CALL NO. 443  
CONTRACT ID NO. 142950  
ADDENDUM # 2

Subject: Kenton-Campbell Counties, 121GR14M055-FE02  
Letting May 30, 2014

- (1) Revised - General Note - Page 32 of 73
- (2) Added - Detour Plans - Pages 40(a)-40(b) of 73

# WB 4th Street Ramp to I-75NB Detour

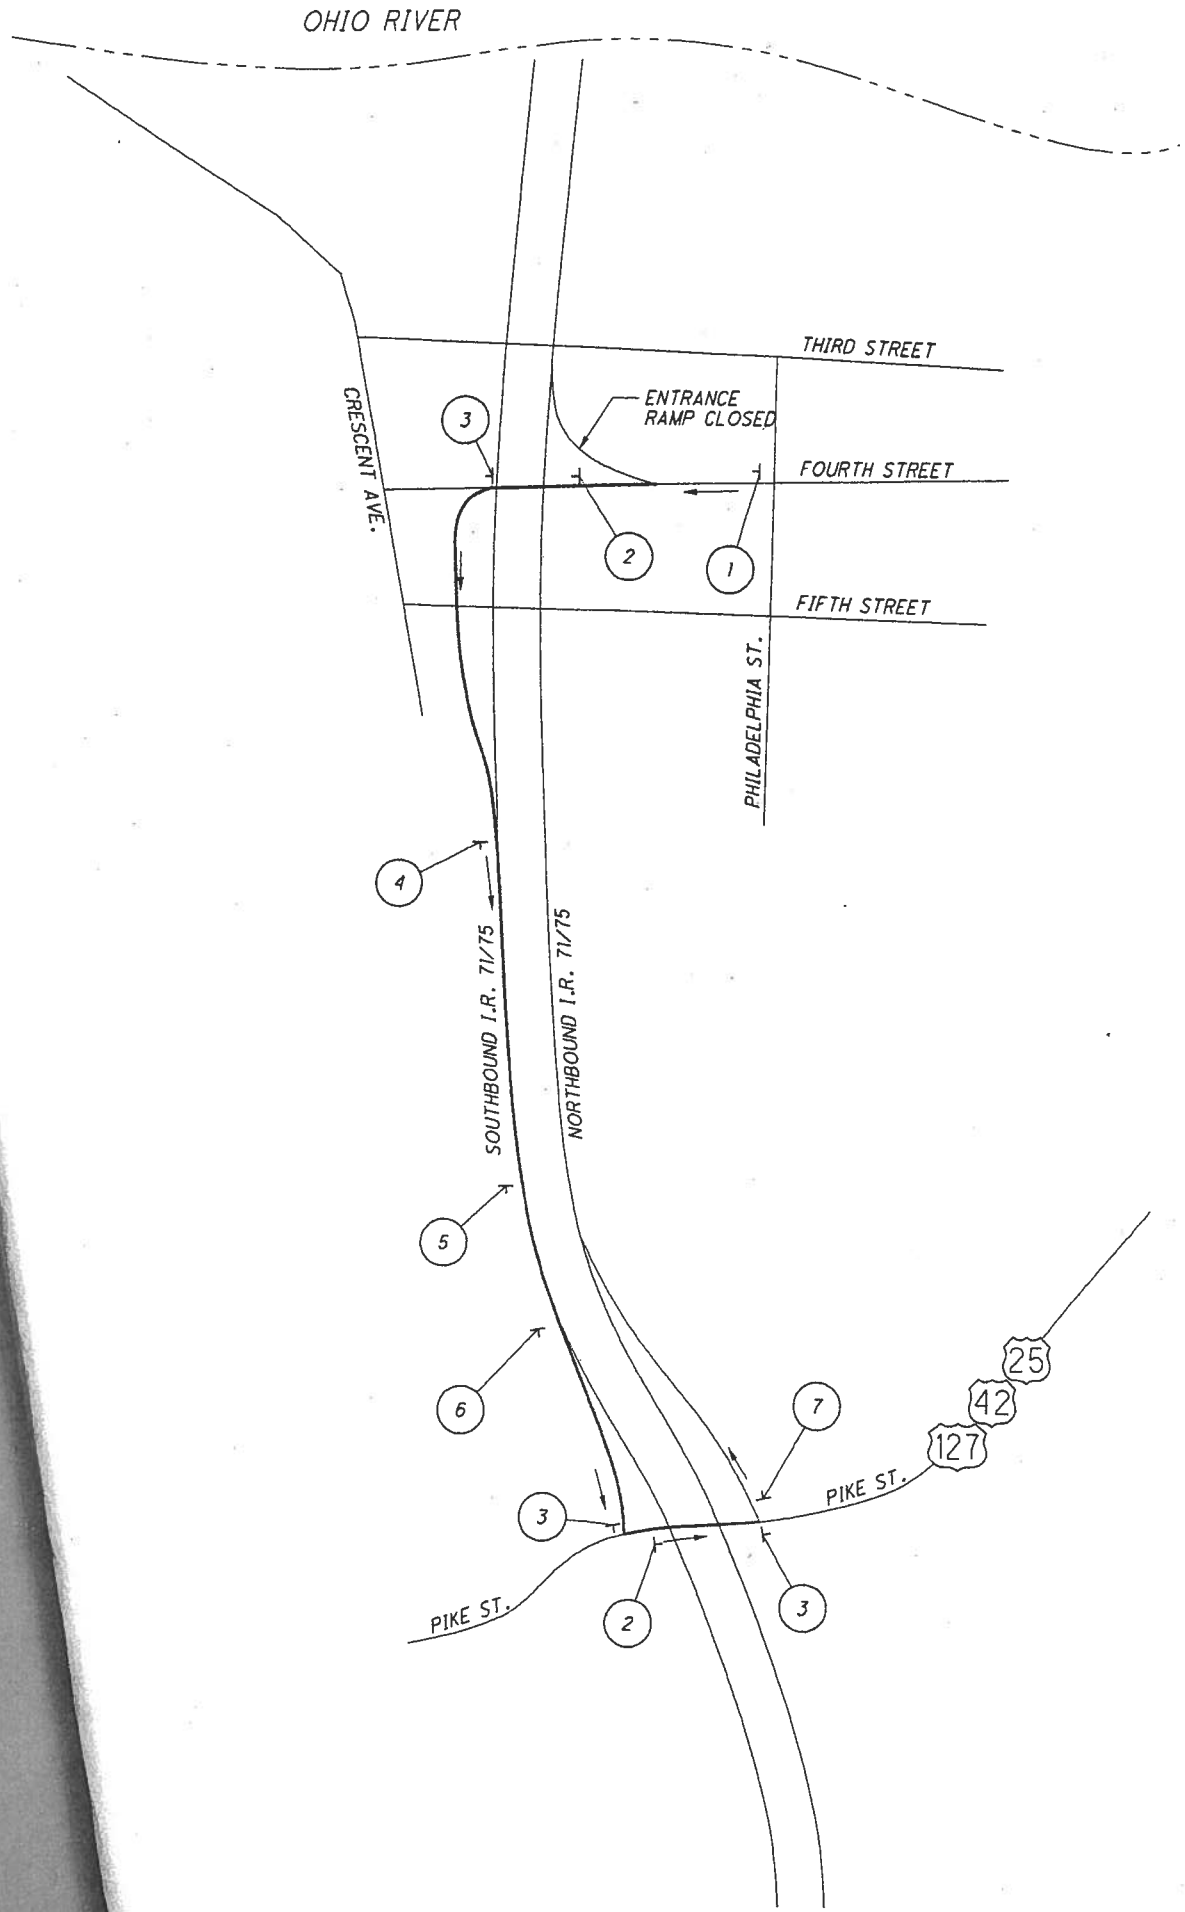
Use single right lane closures and left lane closures on I-75/I-71 northbound per KYTC Standard Drawings from 10:00 PM until 6:00 AM each day. The Forth Street Ramp to I-75/I-71 NB shall be closed when using the right lane closure. See attach drawings for recommended detour plan. The M3-1-30 direction signs and M1-1-36-2 Interstate shield signs shown in the detour plan may be eliminated. Contrary to section 108.09 of the KYTC Standard Specification the contractor will be assessed a liquidated damage of \$500.00 per hour or any portion of an hour for any lane closure outside the allotted time
